MONTGOMERY COUNTY MARYLAND
SOLICITATION ADDENDUM # 2
IFB # 1005807
06/22/2011

FOR THE PROCUREMENT OF: **Parking Garage No. 5, Structural Repairs & Restoration.**

DESCRIPTION OF ADDENDUM:

1. Change to the Terms and Conditions of Construction Contract.
2. Changes to the Performance Bond.
3. Revisions and Additions to Specification.
4. Clarifications.
5. Drawings.

S1.03

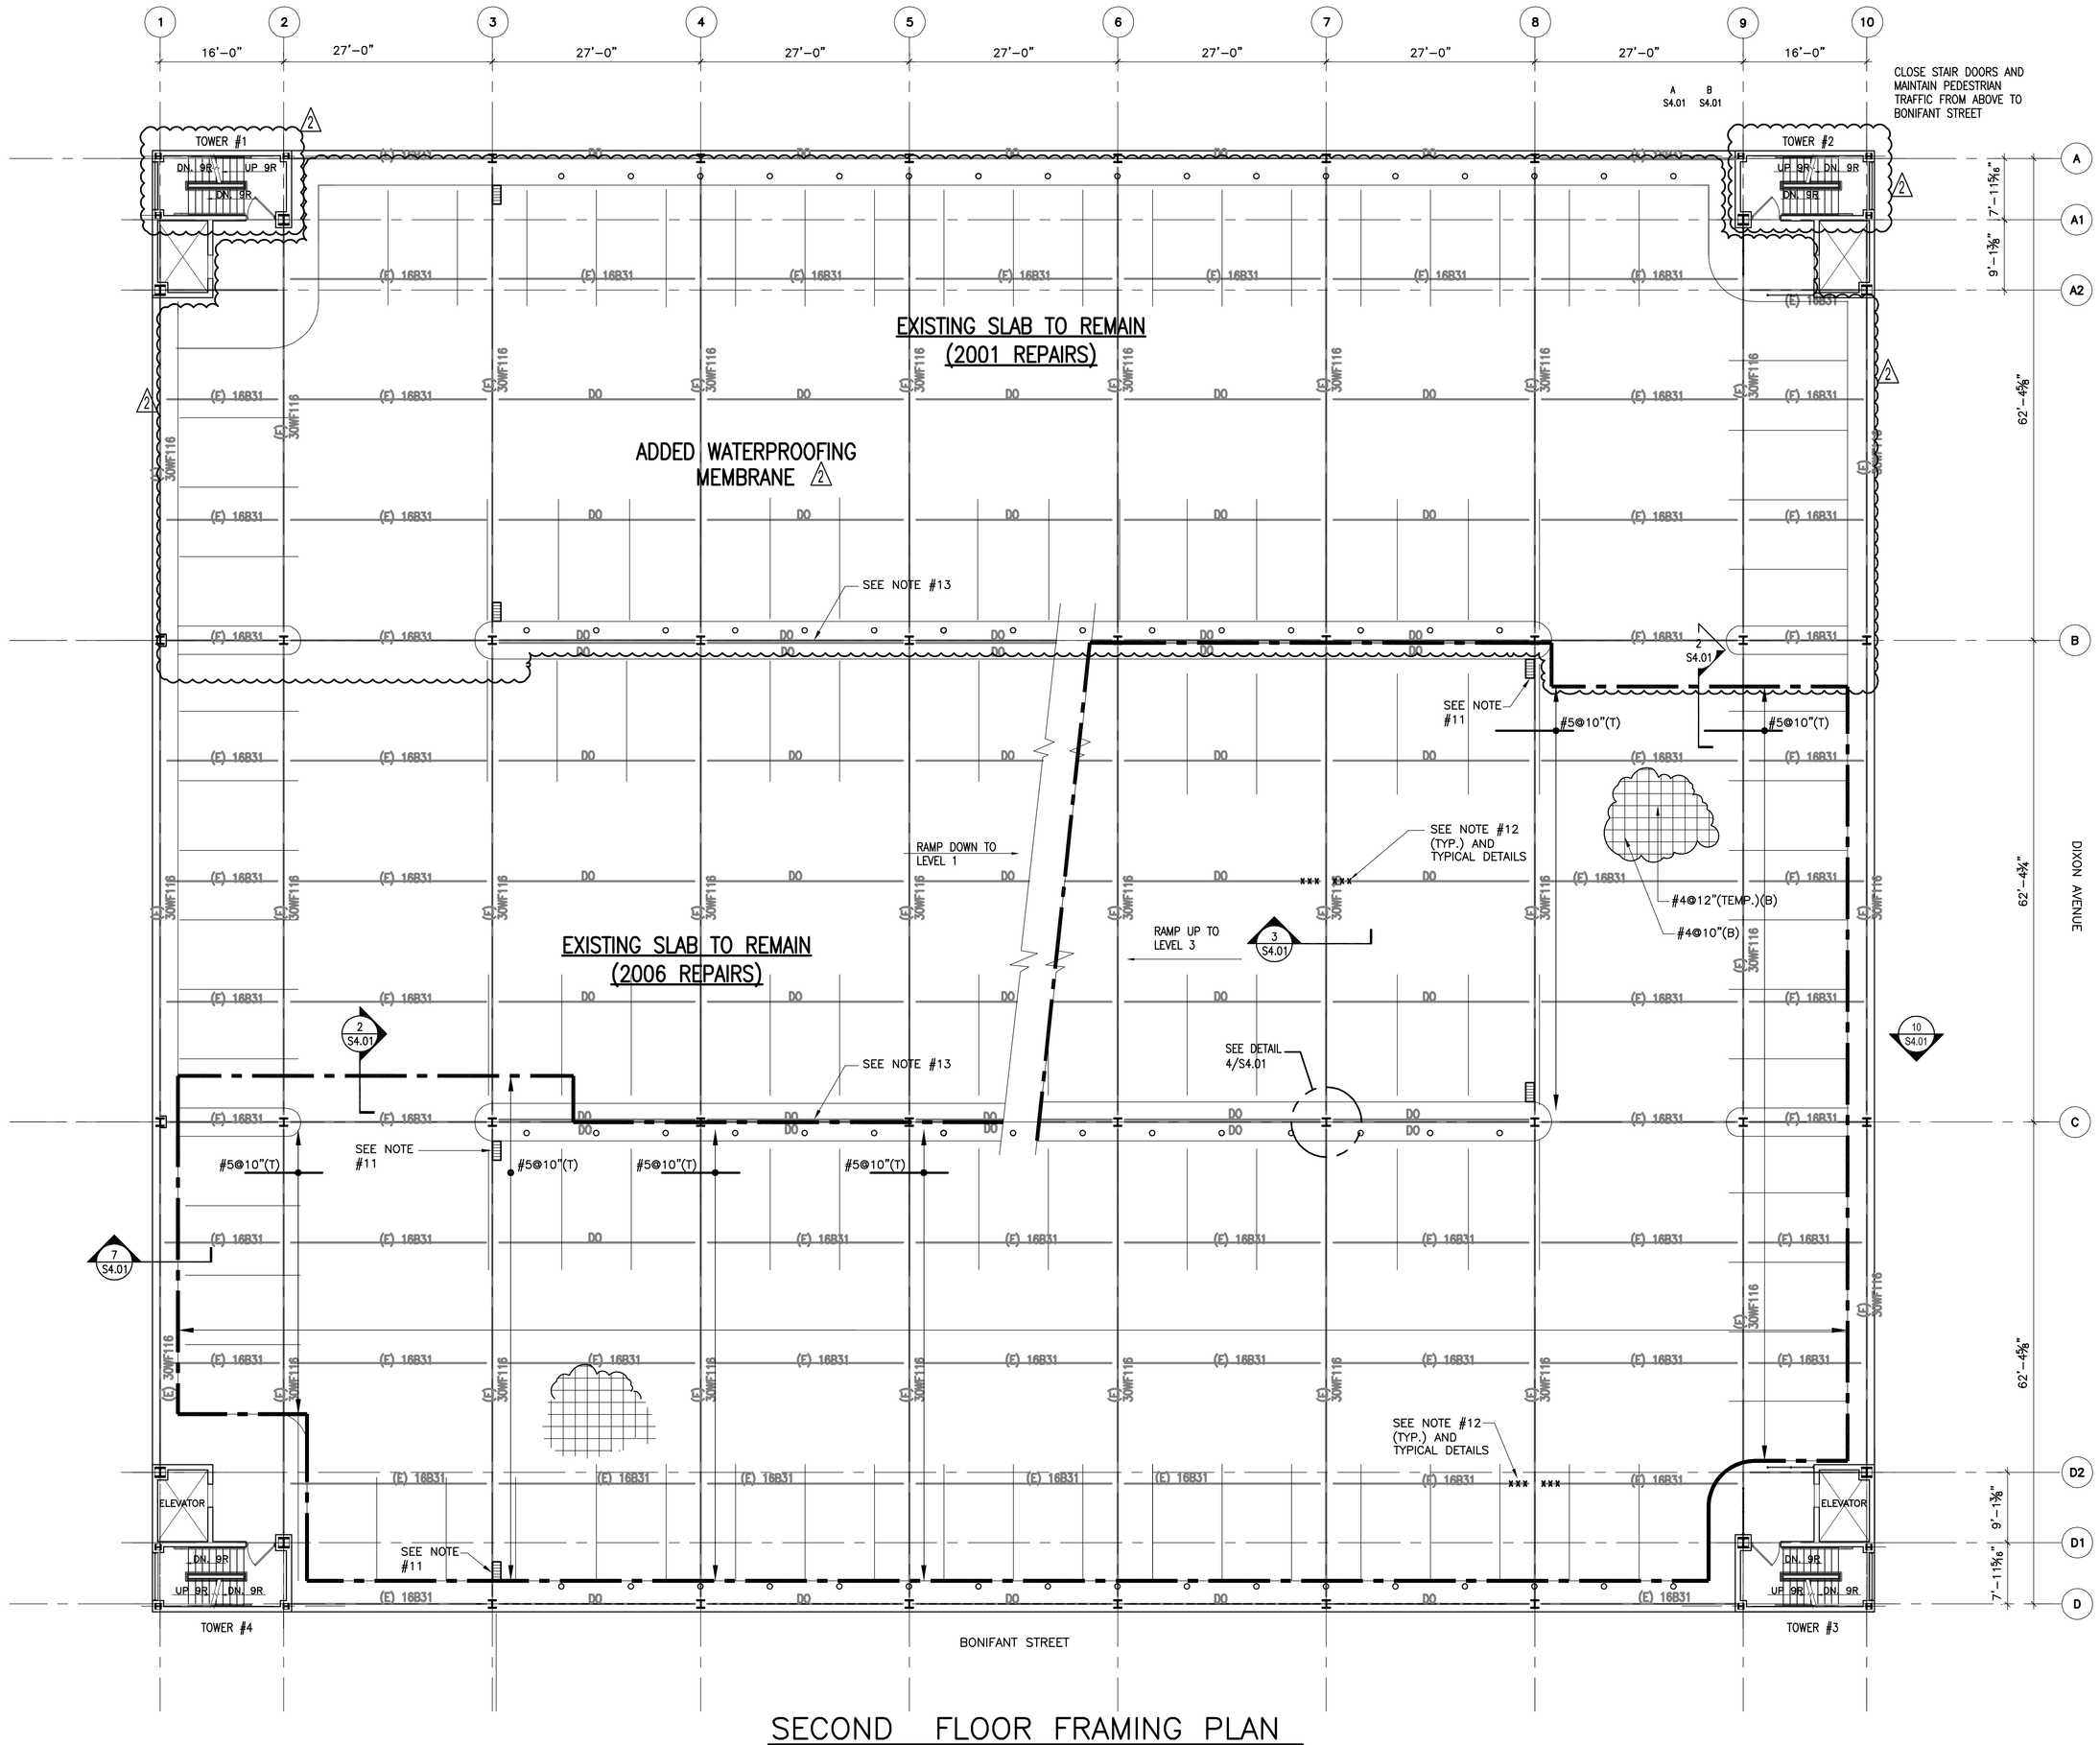
h. Add traffic coating application over level 2 along the north ramp of the garage and within the limits noted on revised drawing S1.03.

a. Remove drawing S1.03 from the current construction documents, issue date May 23, 2011 and replace it with revised Structural Drawing S1.03, issue date June 14, 2011.

△2 – SEE ADDENDUM NO. 1 FOR ADDITIONAL SCOPE OF WORK.
